ADDENDUM No. 2
Request for Competitive Sealed Proposals (CSP)
19CSP073- Renovations at Jordan Elementary School

ADDENDUM NO. 2

PROJECT: BARBARA JORDAN ELEMENTARY SCHOOL
ADDITIONS & RENOVATIONS

PROJECT NO: S&C #R092017 / AISD #180011

E2.01

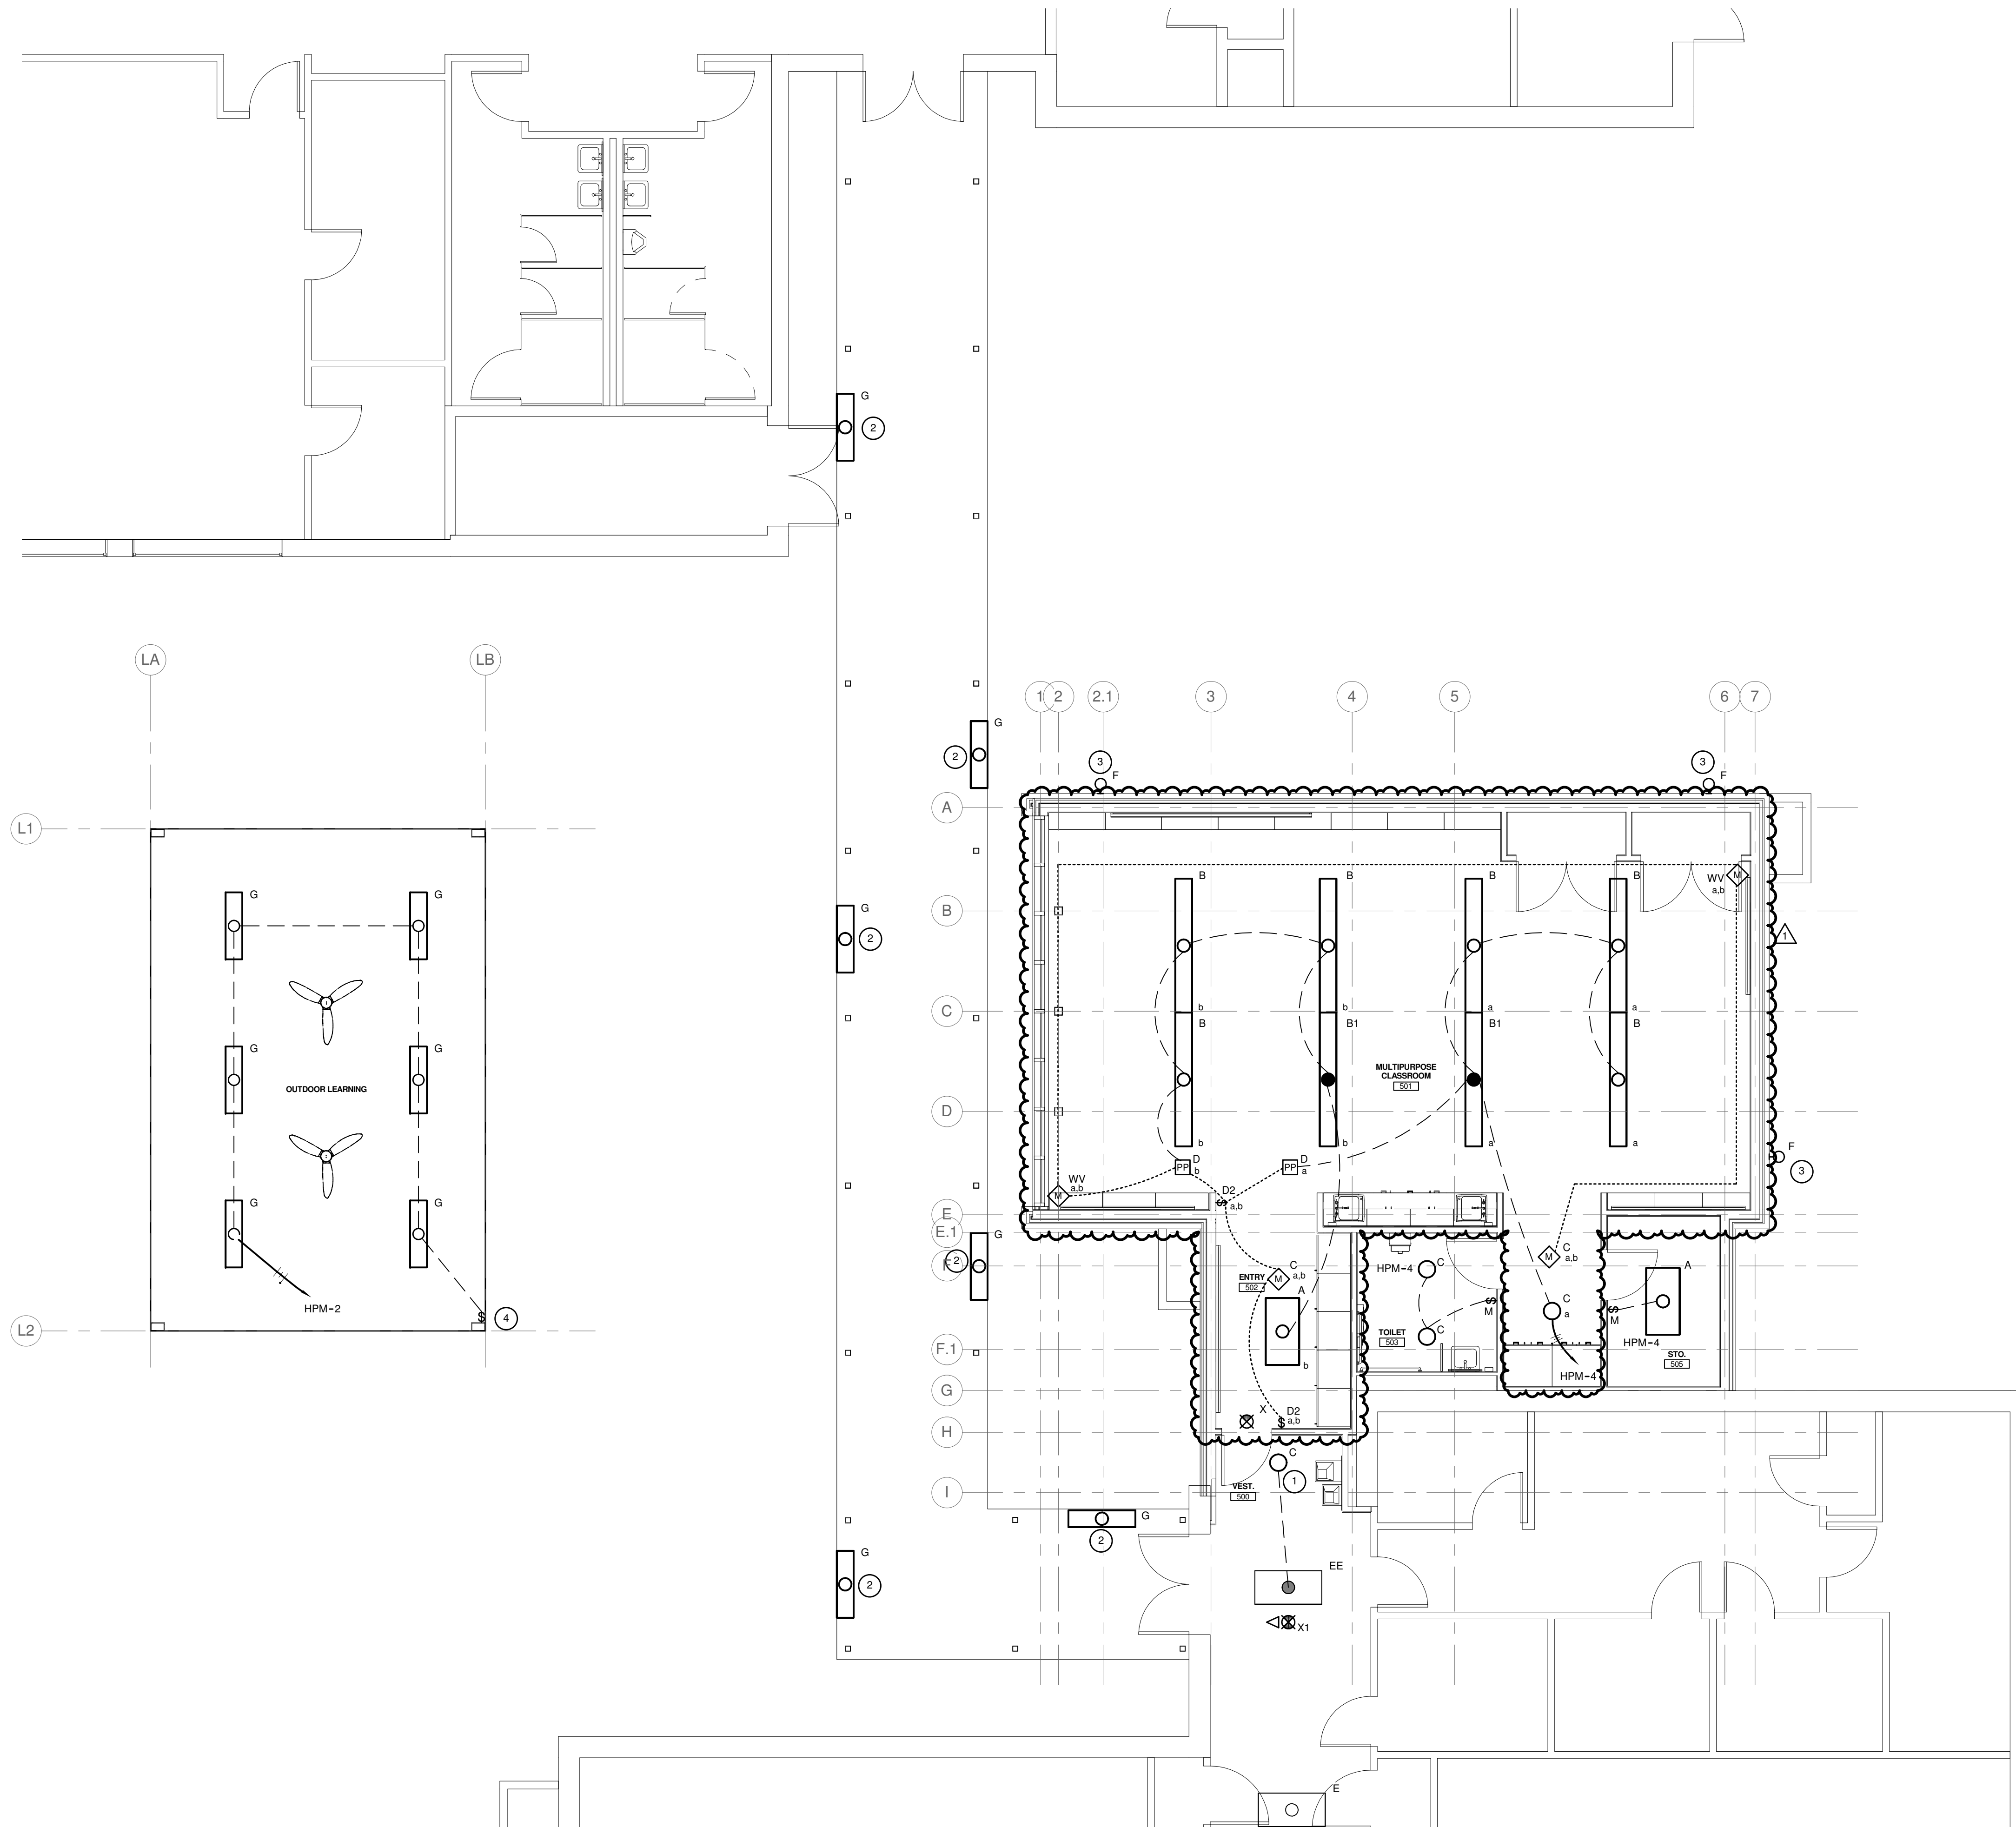
- Item E1 Sheet E2.01 – The switching for the Multipurpose Classroom lighting has been revised to provide switching of the four rows of suspended light fixtures into two groups. One group of two rows on the northeast side of the room and another group of two rows on the southwest side of the room. This will allow the two rows of four fixtures near the window wall to be turned off / dimmed while the other two rows of four fixtures can be on. This shall be done using Acuity nLight lighting control components including two single gang devices that accomplish the same function: one single gang box at the entrance to the classroom's vestibule (from the corridor) and one single gang device at the entry to the classroom itself. Either of the two devices will provide control to the classroom as described above. Refer to attached revised drawing E2.01.
